Town of Hilton Head Island
Design Review Board Meeting
Tuesday, July 26, 2022 – 1:15 p.m.
AGENDA

DESIGN TEAM/DRB COMMENT SHEET

PROJECT NAME: Lowes Foods

DRB#: DRB-001835-2022

A1 PROPOSED EXTERIOR SHOPPING CART CORRAL
.2 SCALE: NTS

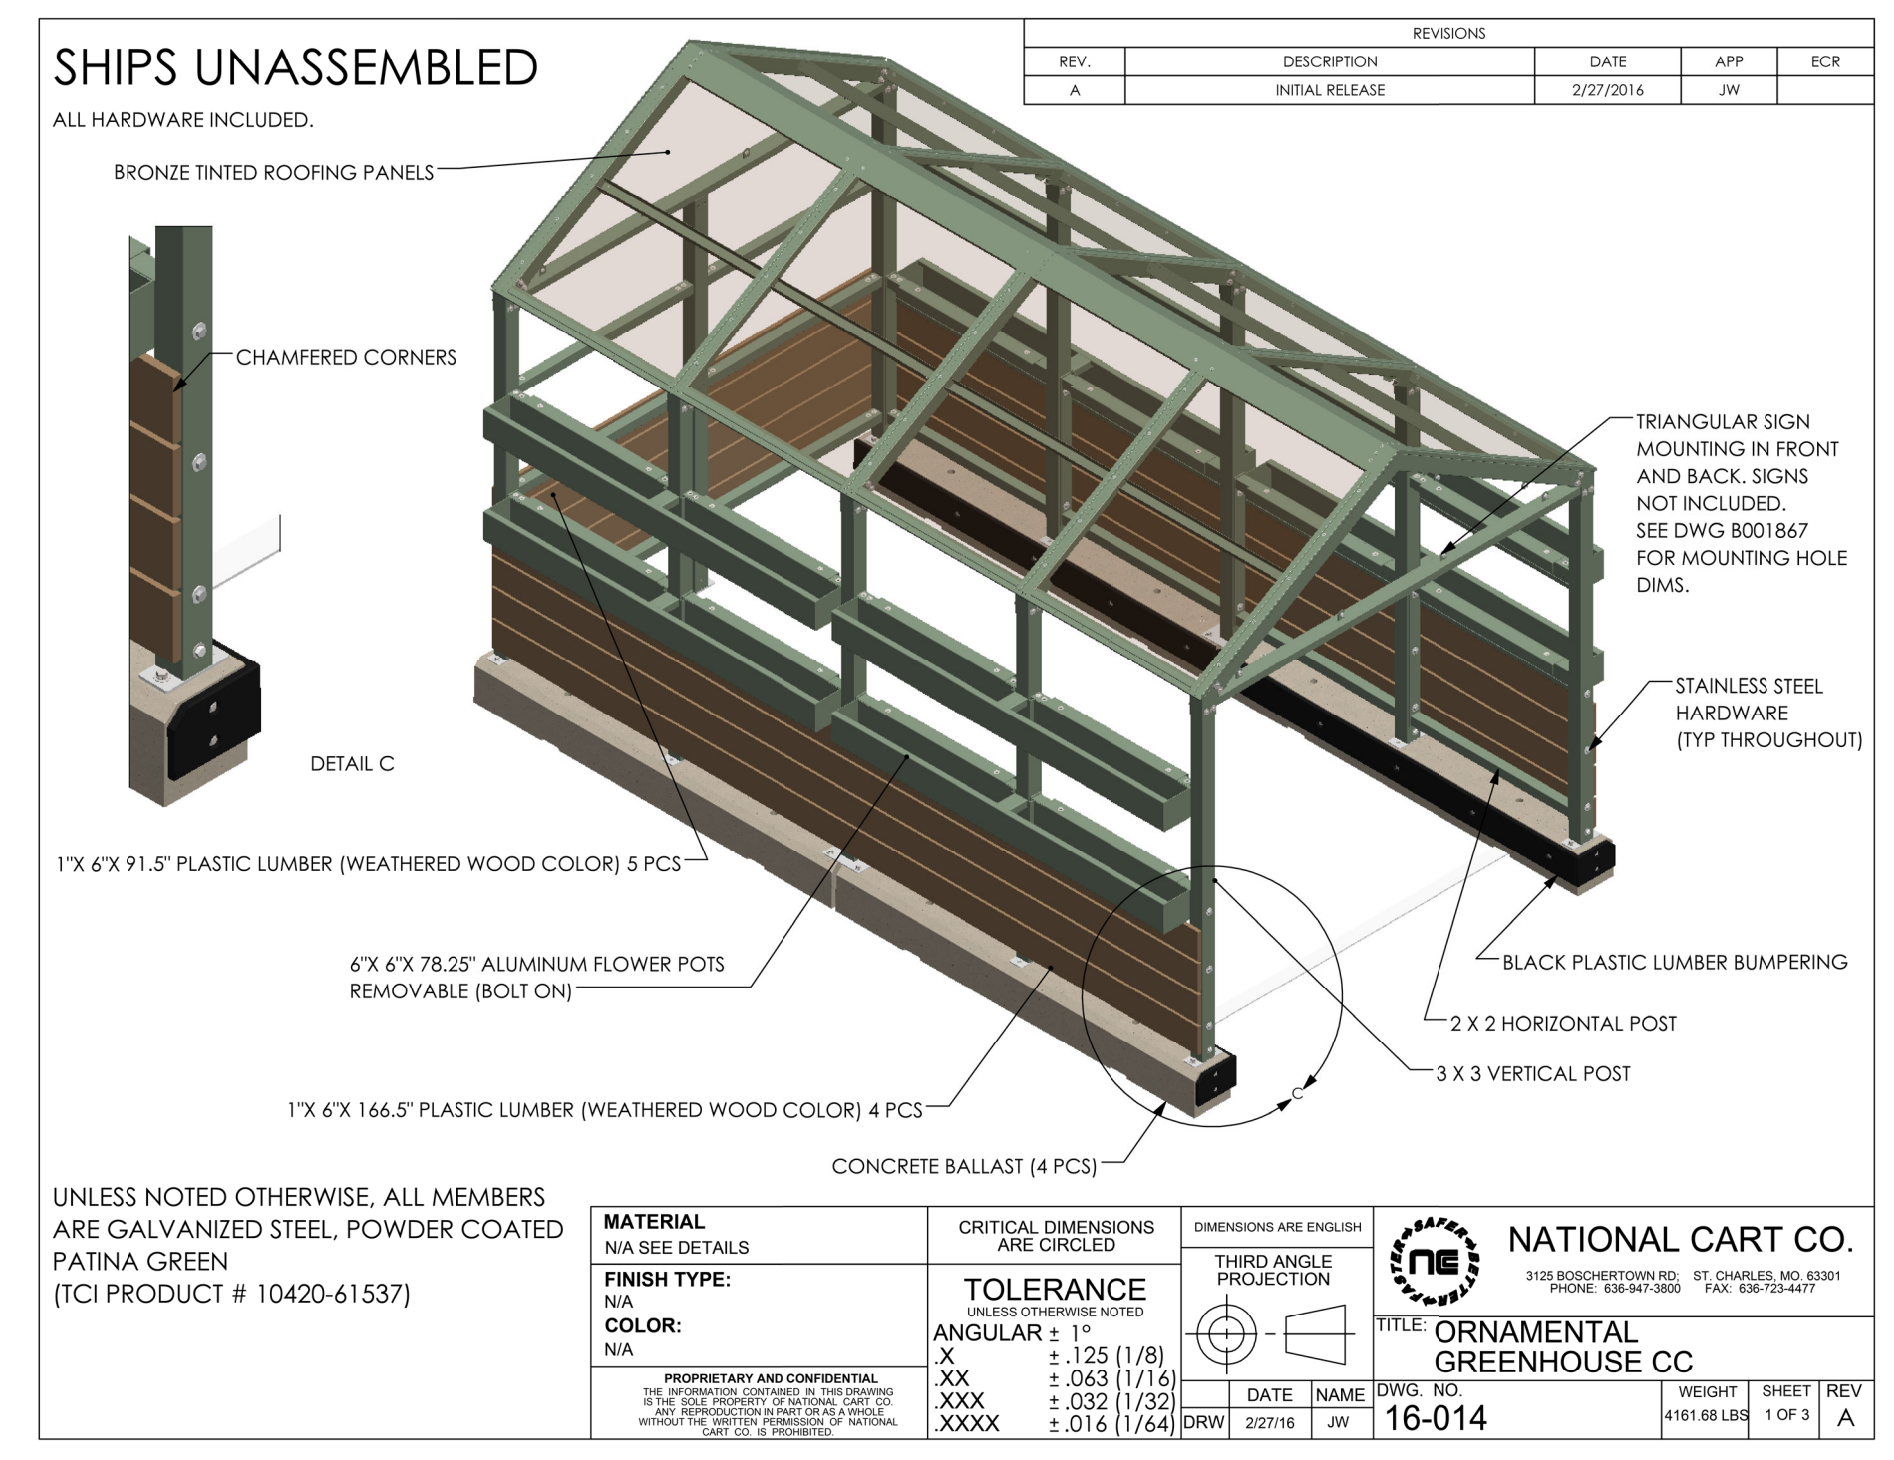
1. Provide a specification for the traffic calming pedestrian crossing.
2. Add a canopy over the door on the north elevation.
3. Remove the flower boxes from the cart corral.
4. Add any non LMO compliant parking spaces to adjacent landscape island.
5. Provide a landscape plan that includes a planting schedule.

DRAWING TITLE
PLANTING PLAN

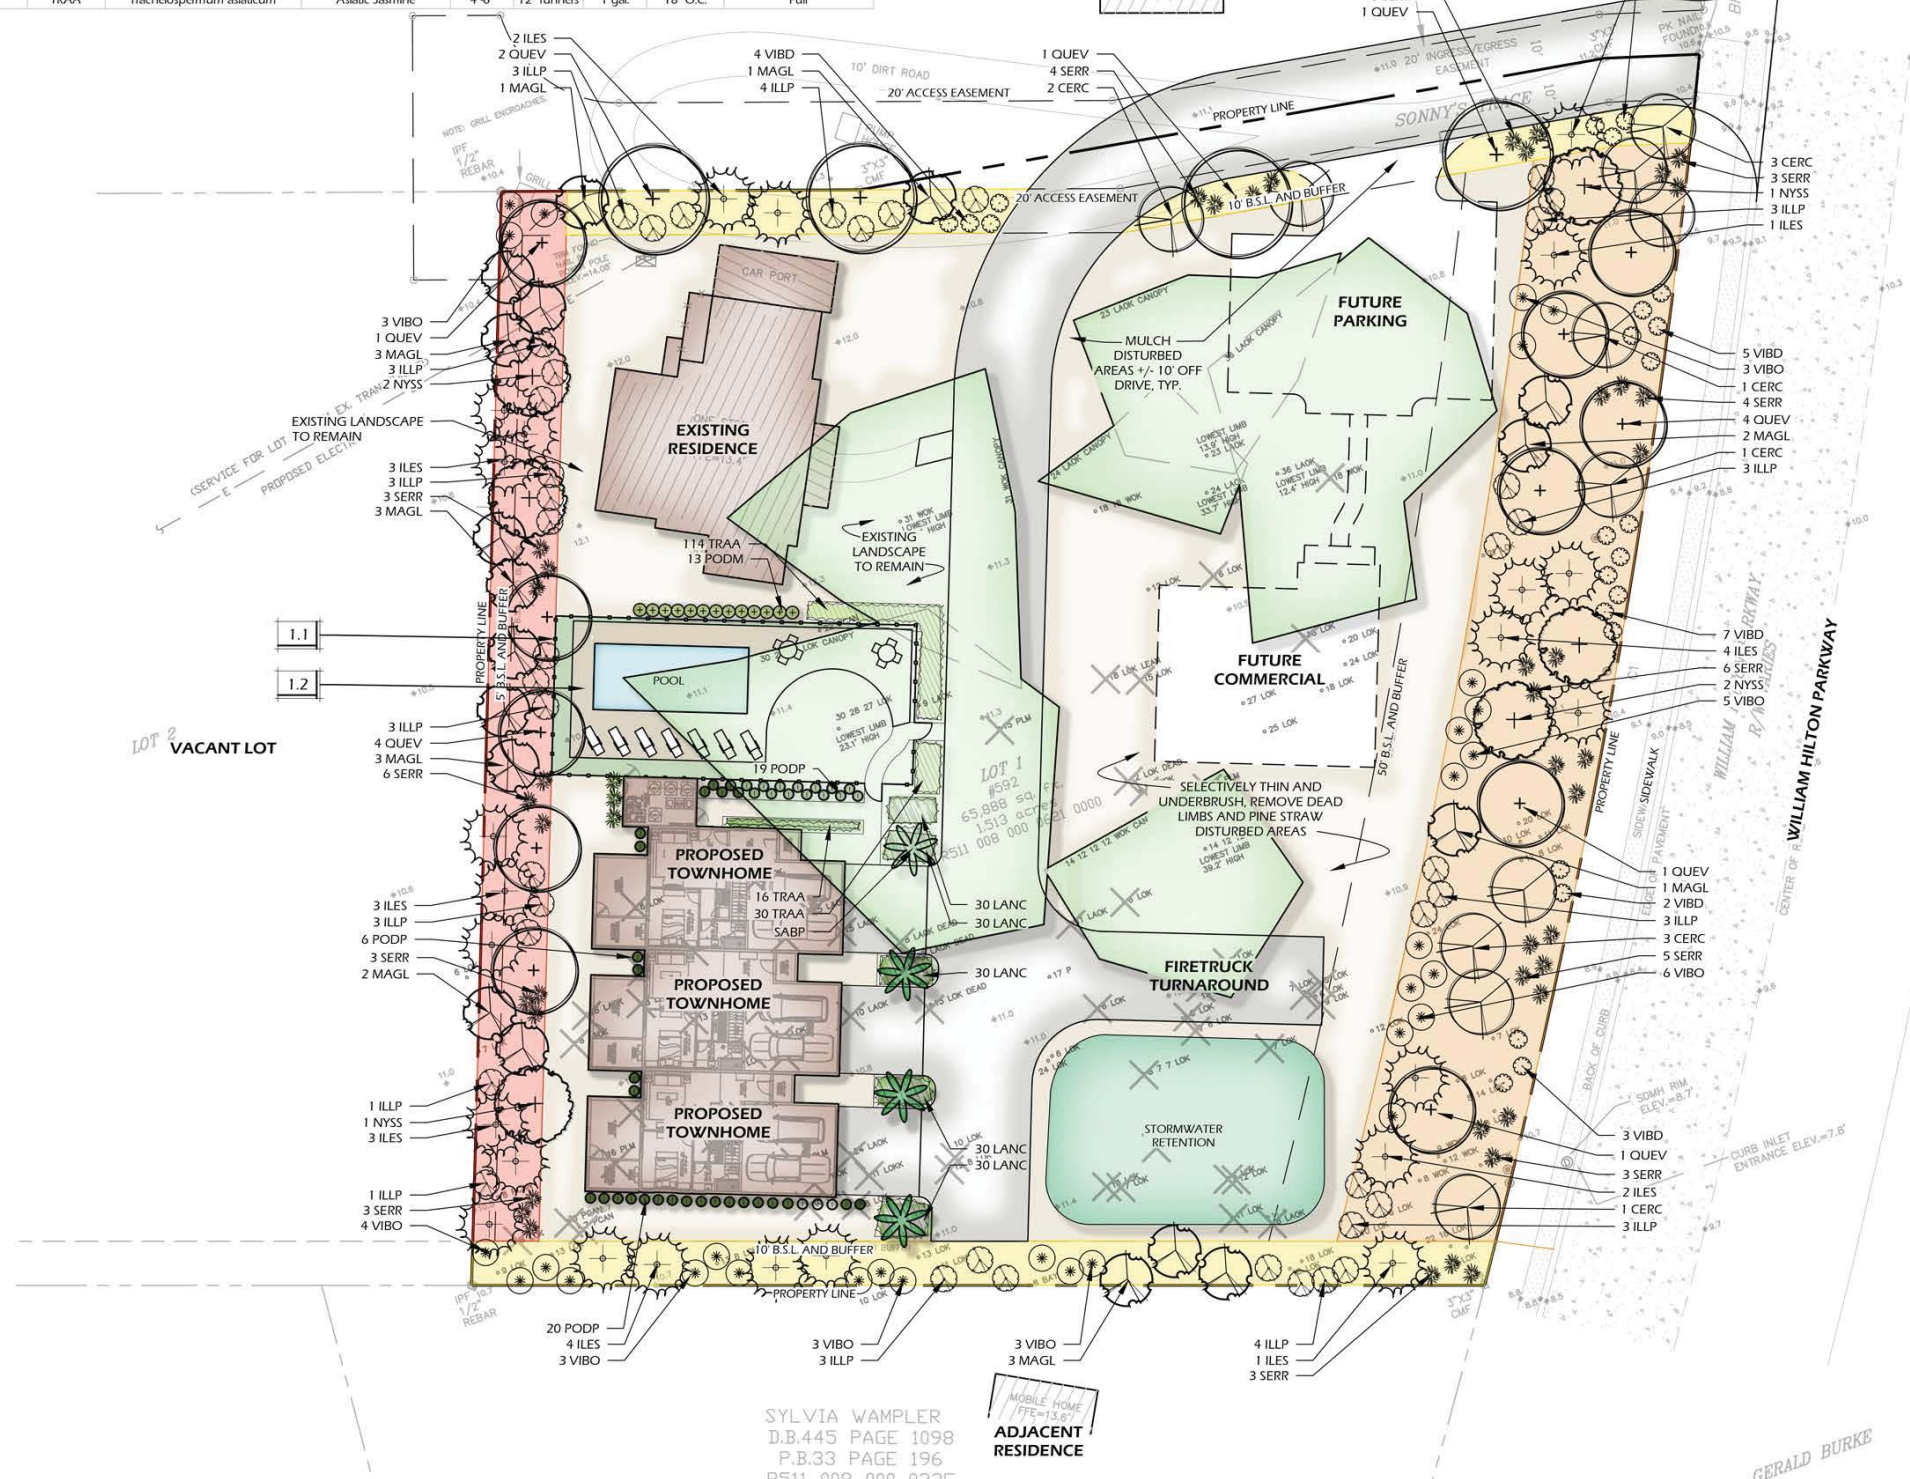
DESIGN GUIDE/LMO CRITERIA	Complies Yes	No	Not Applicable	Comments or Conditions
Treats the Landscape as a major element of the project	<input type="checkbox"/>	<input type="checkbox"/>	<input type="checkbox"/>	How is the stormwater pond planted?
